Report: TAB REPORT
Function: Test, Adjust, & Balance
Date: 05/31/2024

PROJECT
06-03-24 WAWA #8443 HAZLET, NJ

Project: 06-03-24 WAWA #8443 HAZLET, NJ

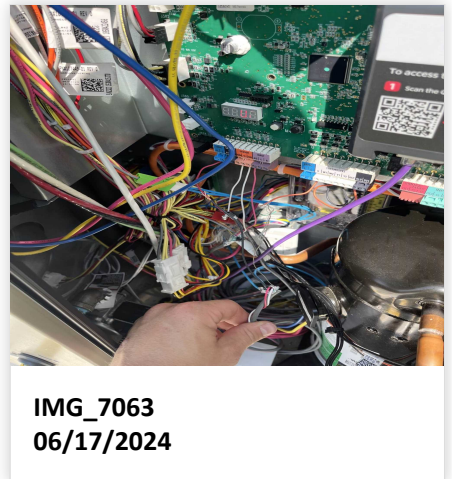
Issue Name : RTU-3 Humidity sensor issue
Description : The humidity sensor is not reading a constant value. The reading fluctuates from 44%-76%-88% and back. Wiring looks to have come undone or is incorrect. Recommend Mc rewire and double check sensor health.

EF-1

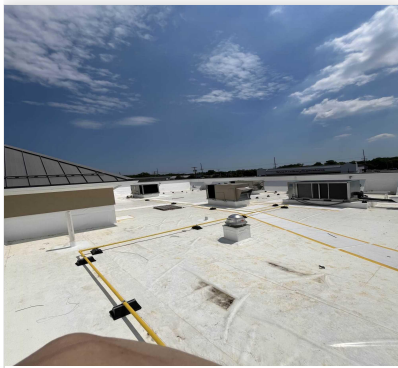
Issue Name : EF 1 needs a disconnect switch
Description : The speed controller was fried due to faulty wiring. Fan is operating at design airflow when wired direct so a replacement speed controller is not required. But a service disconnect should be installed for safety purposes.
Created By : National TAB **Assigned To :** National TAB - Brianna Biggs
Status : Open
Priority : High **Asset Tag :** EF1
Originated Date : 06/04/2024 - Cody Collett - National TAB

- **06/17/2024 National TAB - Tyler Youells**
 - Upon Return trip to complete TAB there is still no disconnect switch installed. Note the junction box is also open with no cover. recommend installing disconnect switch.
